**STAFF REPORT**  
(Preliminary Plat)

**CASE NUMBER:** SUB 2006-02 -- USD 385 ADDITION

**STAFF REPORT**  
(Final Plat, Preliminary Plat Approved 1/26/06)

**CASE NUMBER:** SUB 2006-02 -- USD 385 ADDITION

**SUB 2006-02 -- Preliminary Plat of USD 385 ADDITION**

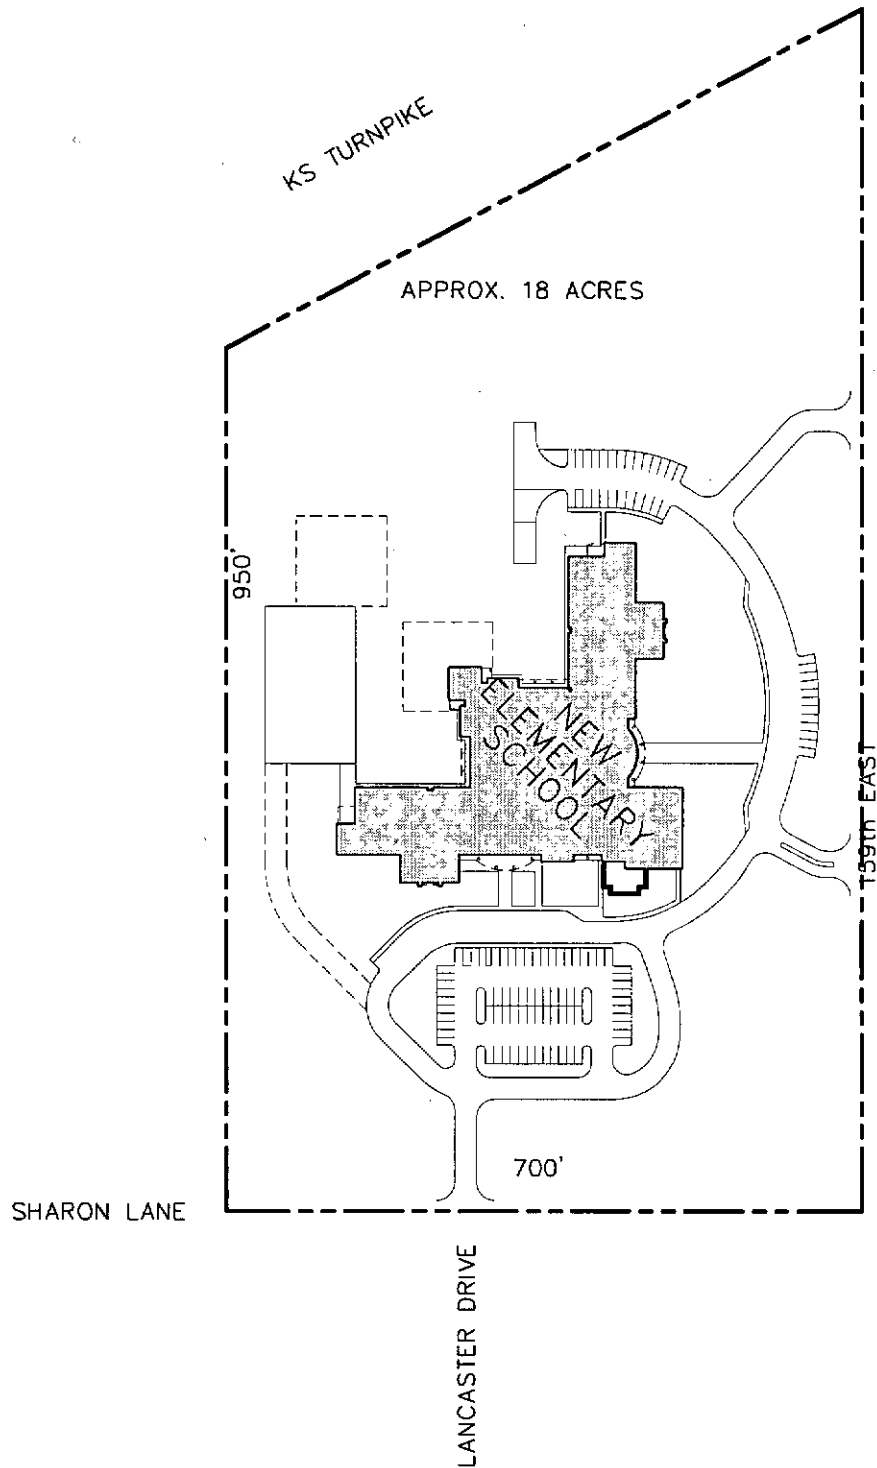
- A. Prior to this plat being scheduled for City Council review, annexation of the property will need to be completed. Upon annexation, the property will be zoned SF-5, Single-Family Residential.

- B. Municipal services appear to be available to serve the site. Unless petitions for extensions are provided, in lieu of assessment fees are needed for sewer lateral and water main.

- C. City Engineering needs to comment on the status of the applicant's drainage concept. County Engineering requests a drainage plan.
- D. Additional right of way is required in the area of KTA bridge and fill.

- E. County Public Works recommends Wichita and Andover resolve which city will annex and maintain 159<sup>th</sup> E.
- F. Traffic Engineering has requested right/left turn lanes on 159<sup>th</sup> for main entrance.

- G. County Engineering needs to comment on the access controls. The plat proposes two openings along 159<sup>th</sup> St. East . The final plat shall reference the dedication of access controls in the platlor's text. Due to poor sight distance over KTA bridge, openings are limited to to one opening on 159<sup>th</sup> St. across from Terradyne. Complete access control needs to be platted adjoining the Kansas Turnpike.

- H. If any drainage will be directed onto the Kansas Turnpike, a letter shall be provided from KTA indicating their agreement to accept such drainage.

- I. The final plat tracing shall state in the platlor's text the purposes of the proposed reserve as well as the ownership and maintenance responsibilities.

- J. Provisions shall be made for ownership and maintenance of the proposed reserve. A covenant shall be submitted regarding ownership and maintenance responsibilities.

- K. For those reserves being platted for drainage purposes, the required covenant that provides for ownership and maintenance of the reserves, shall grant to the appropriate governing body the authority to maintain the drainage reserves in the event the owner(s) fail to do so. The covenant shall provide for the cost of such maintenance to be charged back to the owner(s) by the governing body.

- L. GIS has requested that the streets be labeled as Sharon Ln and Lancaster Dr.
- M. The Applicant is reminded that a platting binder is required with the final plat. Approval of this plat will be subject to submittal of this binder and any relevant conditions found by such a review.
